STAFF REPORT

HEARING DATE: 10/13/2020
TO: Mayor & City Council
FROM: Joe Dodson, Associate Planner
208-884-5533
SUBJECT: H-2020-0022
Modern Craftsman at Black Cat

LOCATION: The site is located in the northeast corner of N. Black Cat Rd. and W. Chinden Blvd. (SH 20/26), in the SW ¼ of the SW ¼ of Section 22, Township 4N., Range 1W.

CONCEPT LANDSCAPE PLAN

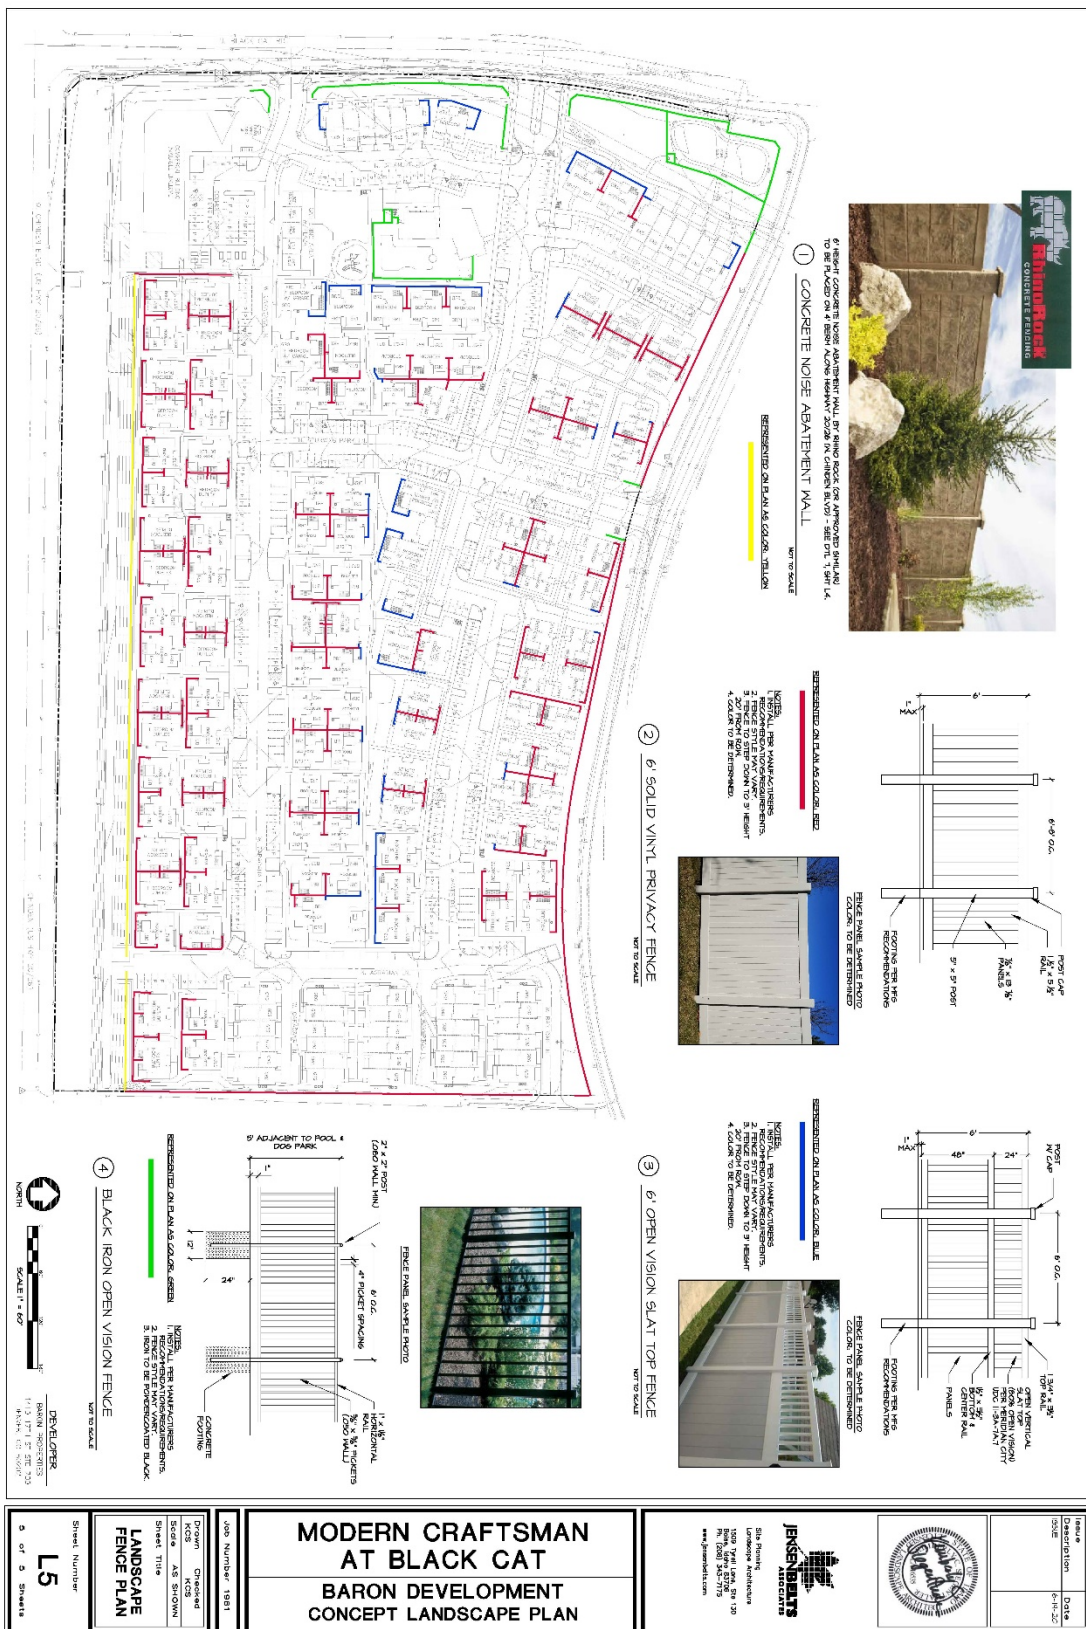
meet the height requirement. Staff notes that this wall is also required to modulate over the course of its length. The submitted landscape plans do not appear to show this modulation so the Applicant will be required to correct the plans prior to final plat submittal.

On the submitted landscape plans, there are no proposed trees or shrubs shown within the required landscape buffer between the commercial lot and SH 20/26. This area of the landscape buffer is also required to be landscaped and Staff is recommending a condition of approval to include landscaping in this area beyond grasses. See Section VII.D for the submitted landscape plans.

Landscaping is required along all pathways (including micro-pathways) in accord with the standards listed in *UDC 11-3B-12C*. The total lineal feet of pathways with the required and proposed number of trees are NOT included in the Landscape Calculations table on the submitted landscape plans, sheet L.4. **The addition of this data in the calculations table will be required as a condition of approval.**

- b. Revise the landscape plans to show the required modulation in the required noise attenuation wall along W. Chinden Blvd. in accord with UDC 11-3H-4D.

- c. Revise the landscape plans and add trees, shrubs, and other vegetative ground cover to the areas of the landscape buffers between the future commercial buildings and Chinden Blvd. and Black Cat Road in accord with UDC 11-3B-7C

TOWNHOUSES - 6 PLEX

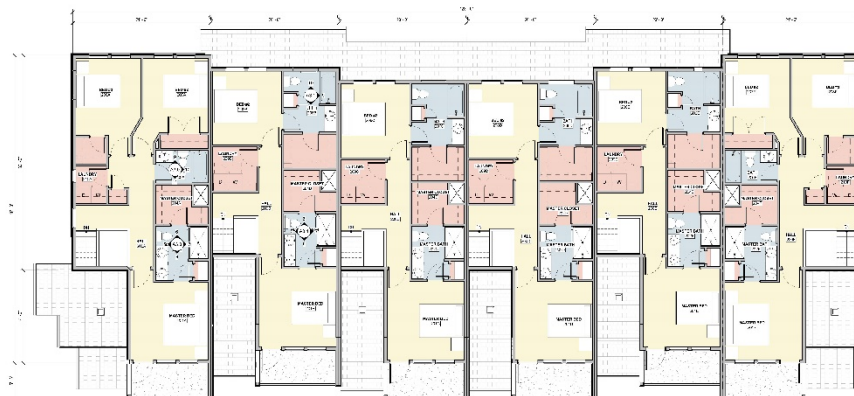
The submitted elevations for the proposed townhome home units show only one field material, stucco. The ASM requires at least two field materials for multi-family development for facades as long as those shown. Staff recommends the Applicant include more of the proposed lap siding along both the front and rear facades to meet the intent of the ASM goals. In addition, the ASM notes that no two multi-family buildings should look the same. To ensure compliance with at least the intent of this requirement, the Applicant should create differentiation between some of the 6-plex, townhome buildings through differing architectural designs and color palettes. Staff is recommending conditions of approval to correct this.

- a. ~~Add additional area of a secondary field material for the proposed townhome units to help break up the large amount of stucco as a field material.~~
